Date: 17 April 2023
Contact: Liza TEO
Location: City Development
Telephone: 55828847
Your reference:
Our reference: OPW/2023/311

INFORMATION REQUEST

Lot 188 RP173728, Lot 189 RP173728, Lot 190 RP173728, Lot 191 RP173728, Lot 192 RP173728
– 79 Courtney Drive, UPPER COOMERA QLD 4209

OPERATIONAL WORKS ASSESSMENT

Figure 1: batters within Park Lot 1005.

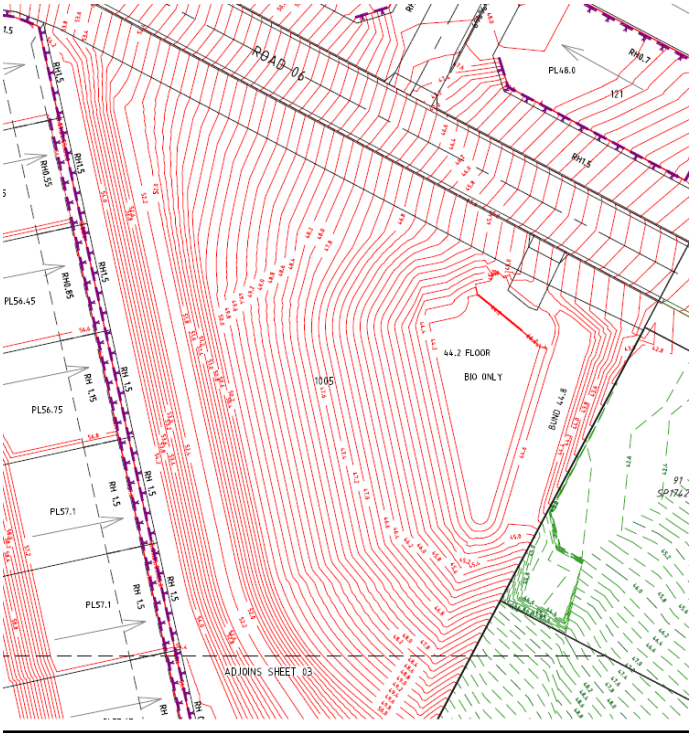
8. Batters within Lot 1005

In pre-lodgement meeting discussions between the applicant and Council a batter design of maximum 1:2 batters of generally 2m high was agreed to, with a 1m bench in-between each batter, to facilitate safe pedestrian access for Council staff and contractors. Whilst this is generally in accordance with this design the applicant is requested to demonstrate the following:

- a. No batters of a steeper grade than 1:2 within Park Lot 1005. All batters must be 1:2 or less;
- b. Provide a 1m wide maintenance access bench to any 1:2 batters that are 2m high;
- c. Include a 1m maintenance access bench provided between the change in batter grade at the 50m contour level; and
- d. Provide a 3m wide maintenance access track around the bio-basin.

Figure 2: batters extending from Park Lot 1003 drainage reserve extending into Park Lot 1004

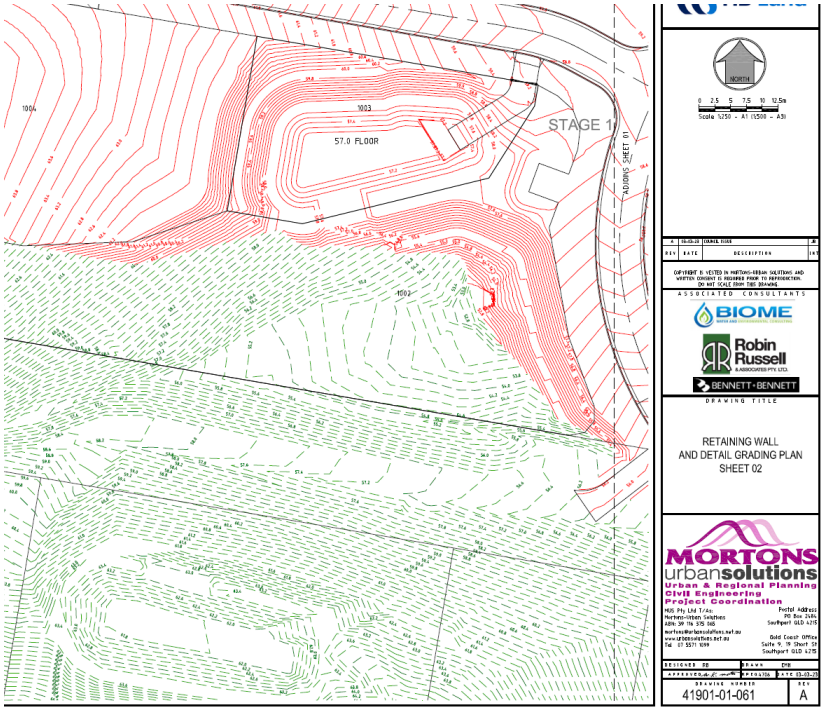
9. Batters within Drainage Reserve 1003

In accordance with condition 26 of the overriding approval the applicant is requested to amend plans to ensure all batters associated with park lot drainage reserve Lot 1003:

- a. Not extend into the adjacent Park lots dedicated for the purposes of recreation (non-trunk) or conservation.
- b. Batters associated with each Bio basin within the drainage reserve be fully contained within each lot.
